Access Compliance Report

Public Rights-of-Way

(Curb Ramps)

Intersection ID: 10019976	Main Street: ARENA_BV	Cross Street: N/A	Location:	N
ADA ID: B32B9817EAE1	Ramp Type: PerpDiag	Initial Pass/Fail: Fail	Overall Compliance: No	Severity Score: 12.5
Codes/Mitigation Info/Possible Solution		Field Measurements/Component Compliance

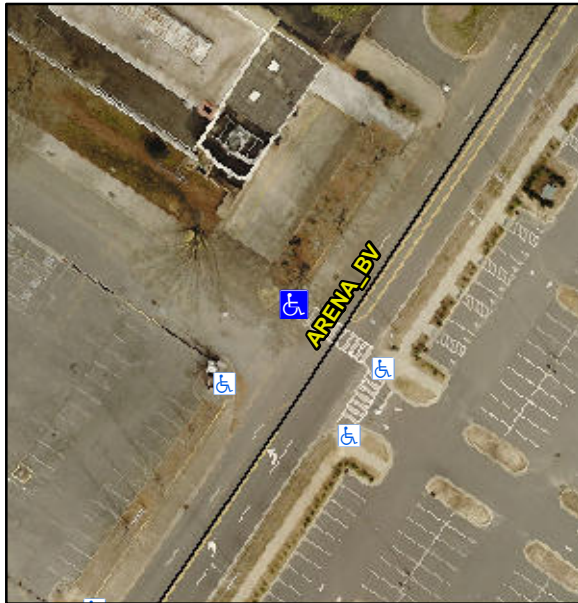
Not Found, R304.5.3

Compliance	Description	Data	Compliance	Description	Data
N/A	Ramp Length (in)	49.5	Yes	Ramp Slope (%)	8.0
Yes	Ramp Width (in)	48.0	No	Ramp XSlope (%)	5.4
N/A	Flare Type LT	N/A	N/A	Flare Type RT	N/A
N/A	Flare Slope LT (%)	N/A	N/A	Flare Slope RT (%)	N/A
N/A	Flare Traversable LT?	N/A	N/A	Flare Traversable RT?	N/A
N/A	Landing Length (in)	N/A	N/A	DWS Provided?	N/A
N/A	Landing Width (in)	N/A	N/A	DWS Contrast?	N/A
N/A	Landing Slope (%)	N/A	N/A	DWS Length (in)	N/A
N/A	Landing X Slope (%)	N/A	N/A	DWS Full Width?	N/A
N/A	Landing Curb? (Y/N)	N/A	N/A	DWS Offset (in)	N/A
N/A	Shared Landing?	N/A			
N/A	Gutter Ponding?	N/A	N/A	Gutter Slope (%)	N/A
N/A	Gutter Lip Ht (in)	N/A	N/A	Gutter X Slope (%)	N/A
N/A	Painted X Walk1?	No	N/A	Painted X Walk2?	Yes
	X Walk 1 Direction	To SW		X Walk 2 Direction	To SE
N/A	X Walk 1 Width (in)	N/A	N/A	X Walk 2 Width (in)	111.0
	X Walk 1 Slope (%)	5.9		X Walk 2 Slope (%)	1.9
	X Walk 1 X Slope (%)	2.3		X Walk 2 X Slope (%)	3.3

Remove & Replace Curb Ramp With Two New Directional Ramps or Equivalent.
